Millstone Nuclear Power Station, Unit No. 3
Response to Request for Additional Information
Inservice Inspection Program
Request for Relief from ASME Section XI

Millstone Nuclear Power Station, Unit No. 3
Response to Request for Additional Information
Inservice Inspection Program
Request for Relief from ASME Section XI
Revised Relief Requests IR-20 and IR-21

Relief Request: IR-20, Rev. 1

Relief Request: IR-21, Rev. 1

SUBJECT RELIEF REQUEST IR-20

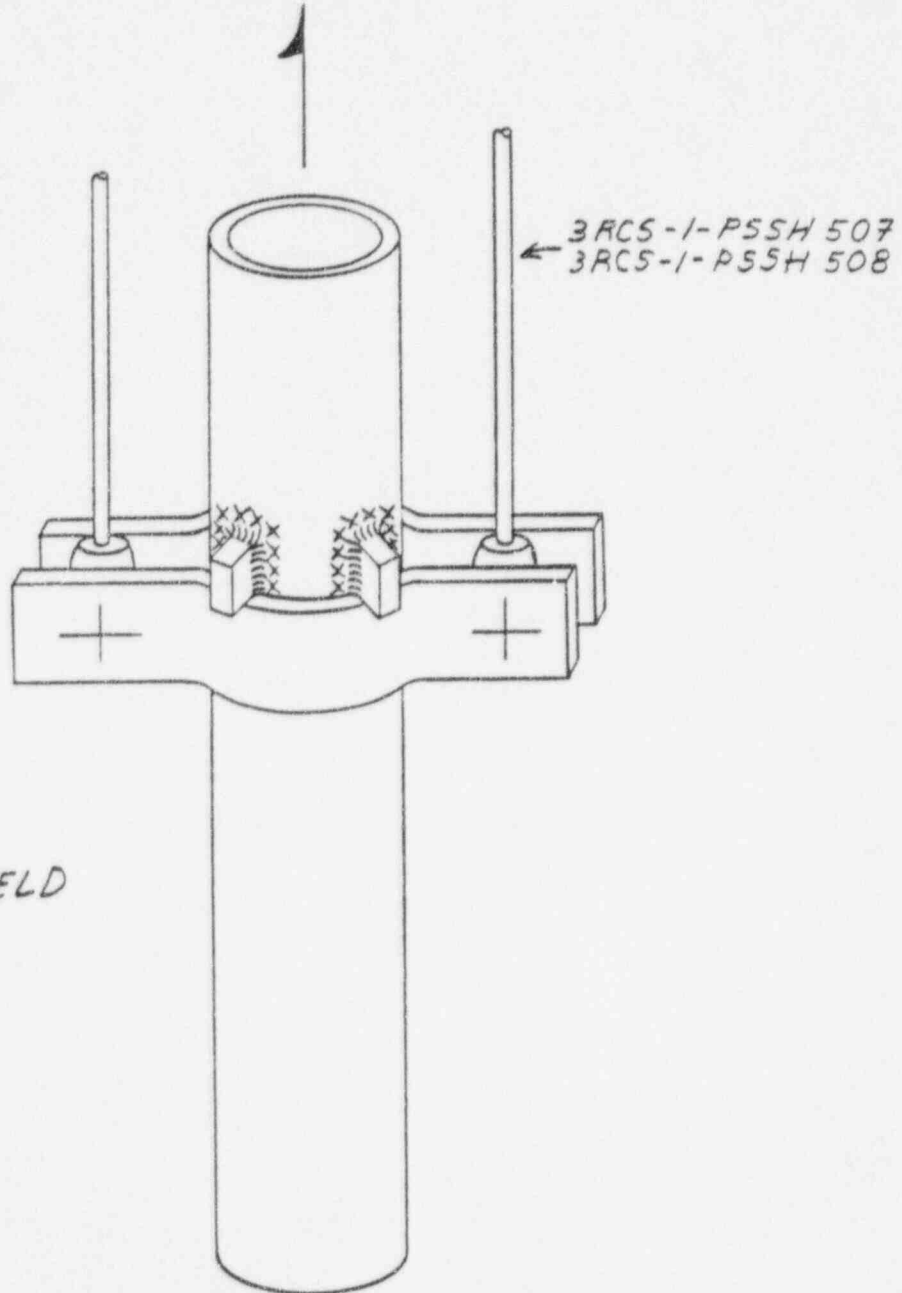
Access to these attachment welds is essentially limited to three sides, as shown on the attached diagram, due to a hanger clamp which prohibits one hundred percent surface examination coverage of the code required examination area. These welded support lugs are welded on three sides located on vertical pipe risers that transmit the load to variable spring can supports. Radiation levels were high, estimated dose rates were 200 - 400 mR/hour general area, 400 - 800 mR/hour on contact, with localized hot spots (crud traps and drain valves) of 10 R - 200 R/hour. In keeping with ALARA, regarding radiation exposure, to disassemble these spring can supports provides a very small increase in examination coverage with a disproportionate impact on personnel exposure. Relief is therefore requested from performing the inservice examination on the inaccessible portions of the exam area base metal located under the pipe clamp as noted in the attached table.

Surface examinations on the accessible 83 percent of the required examination area as required by ASME Section XI, IWB-2500 were performed during the fourth refueling outage. In addition, inservice system leakage tests were performed in accordance with Category B-P, IWB-2500-1.
